Oakland Road Industrial Project

File No. H20-018

Initial Study / Mitigated Negative Declaration

RESPONSES TO PUBLIC COMMENTS AND TEXT CHANGES

Intersection analysis Oakland/Brokaw

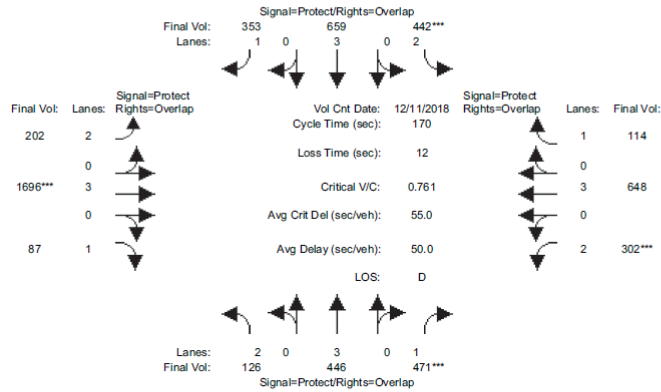
Comment B9: The intersection analysis is incurably flawed as it use unsubstantiated vehicle flow conditions in its modelling, specifically for the eastbound left turn lane from Oakland into Brokaw/Murphy. The model assumes a maximum capacity of 3150 cars/h for the two left lanes combined. Adjusted for a green time of 31.4 seconds per cycle this suggests that the model believes that ~26.25 cars are able to make a left turn per cycle. This is empirically wrong. Based on actual observations on January 29, 2019, a maximum of 16 cars is able to make a left-turn at the intersection per cycle during congested PM peak hour conditions. That means that the model is significantly underestimating the current and future delay at the intersection.

The intersection analysis is incurably flawed as it use unsubstantiated vehicle flow conditions in its modelling, specifically for the eastbound left turn lane from Oakland into Brokaw/Murphy. The model assumes a maximum capacity of 3150 cars/h for the two left lanes combined. Adjusted for a green time of 31.4 seconds per cycle this suggests that the model believes that ~26.25 cars are able to make a left turn per cycle. This is empirically wrong. Based on actual observations on January 29, 2019, a maximum of 16 cars is able to make a left-turn at the intersection per cycle during congested PM peak hour conditions. That means that the model is significantly underestimating the current and future delay at the intersection.

Response B9: The intersection level of service analysis discussed in the IS/MND followed the City of San José procedures as outlined in the Transportation Analysis Handbook, 2020. All study intersections were evaluated based on the *2000 Highway Capacity Manual* (HCM) level of service methodology using TRAFFIX software. This method evaluates signalized intersection operations on the basis of average control delay time for all vehicles at the intersection. TRAFFIX is also the Congestion Management Plan (CMP)-designated intersection level of service methodology; thus, the City of San José employs the CMP default values for the analysis parameters. The analysis of intersection operations is outside the bounds of CEQA, with passage of SB 743 requiring evaluation of projects using VMT

and the City's adoption of City Council Policy 5-1 in 2018 establishing the metrics by which CEQA transportation impacts will be evaluated using VMT. The comment does not provide new information that would require additional analysis or result in new significant impacts or mitigation measures than those analyzed and disclosed in the IS/MND and associated appendices, or present new information that would require recirculation of the IS/MND pursuant of CEQA Guideline Section 15073.5.
